Docket No. 50-275, OL-DPR-80  
Docket No. 50-323, OL-DPR-82  
Diablo Canyon Units 1 and 2  
Response to NRC Request for Additional Information Regarding License  
Amendment Request 09-06, "Critical Damping Value for Structural Dynamic  
Qualification of the Control Rod Drive Mechanism Pressure Housings" (TAC Nos.  
ME2995 and ME2996)

**PG&E Response to NRC Request for Additional Information Regarding License Amendment Request (LAR) 09-06, “Critical Damping Value for Structural Dynamic Qualification of the Control Rod Drive Mechanism Pressure Housings”**

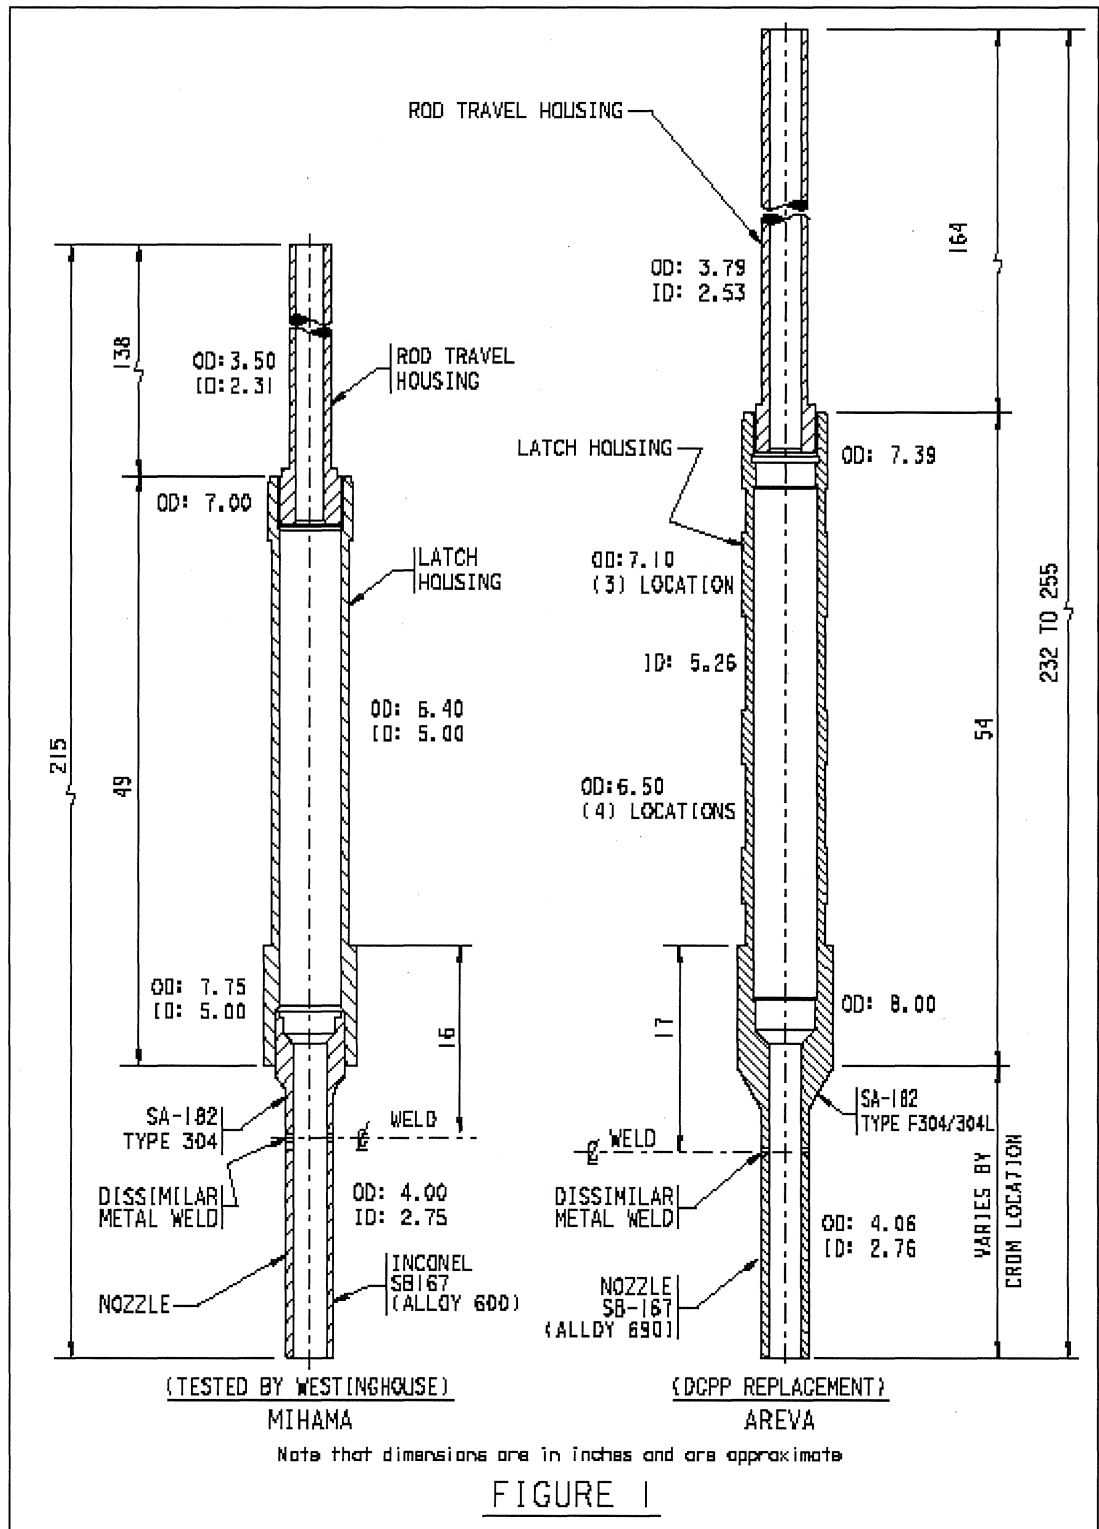
*Pages 3 and 4 along with Figure 1 of the enclosure to PG&E's letter dated December 14, 2010 (DCL-09-086), provide the basis for similarity between the original equipment manufacturer (OEM) CRDM and the new AREVA supplied replacement CRDM from considerations such as the seismic support plate gap, CRDM length, latch housing and rod travel housing materials, CRDM geometrical section properties, operating parameters, appurtenances, and design differences. Provide a similar comparison of the AREVA-supplied replacement CRDMs and the CRDMs tested by Westinghouse, as described in the topical report, WCAP-7921-AR.*

The following provides the comparison of the AREVA-supplied replacement CRDMs and the CRDMs tested by Westinghouse, as described in the topical report, WCAP-7921-AR:

1. *Gap at the seismic support plates.* The AREVA-supplied replacement CRDMs provide a 0.070 inch gap (cold) and a 0.100 inch gap (hot) between the CRDM seismic support plates. The Westinghouse CRDM testing determined the damping

values for three different gap values: zero gap, 0.015 inch gap, and 0.060 inch gap. The testing showed larger gaps significantly increased the measured CRDM damping. The seismic support plate gaps for the AREVA-supplied CRDMs exceed the maximum gaps included in the Westinghouse testing to ensure the test results are applicable to the replacement CRDM installation.

2. *CRDM length.* The Westinghouse CRDM damping testing utilized a model L-105B CRDM that is designed for a 10-foot core. Diablo Canyon has 12-foot cores and therefore the AREVA-supplied CRDMs are approximately 17 to 40 inches longer than the tested L-105B CRDM as measured from the top of the reactor vessel closure head to the top of the rod travel housing. See Figure 1. It is expected that the longer latch assembly and rod travel housing of the AREVA-supplied CRDMs will have a positive effect on damping (ie: higher damping when compared to the L-105B tested CRDM).

3. *Latch Housing and Rod Travel Housing (RTH) Materials.* The AREVA-supplied CRDMs and the L-105B tested CRDM both use type 304 stainless steel.
4. *Section Properties.* Figure 1 shows section property differences between the L-105B CRDMs that were tested and the AREVA-supplied CRDMs. The original Diablo Canyon L-106A CRDMs supplied by Westinghouse have essentially the same section properties as the AREVA-supplied CRDMs. Westinghouse has determined these section property differences will have negligible impact on CRDM damping. Other U.S. plants base their current license basis acceptance to use 5 percent damping for their CRDM analysis on the Westinghouse L-105B testing.
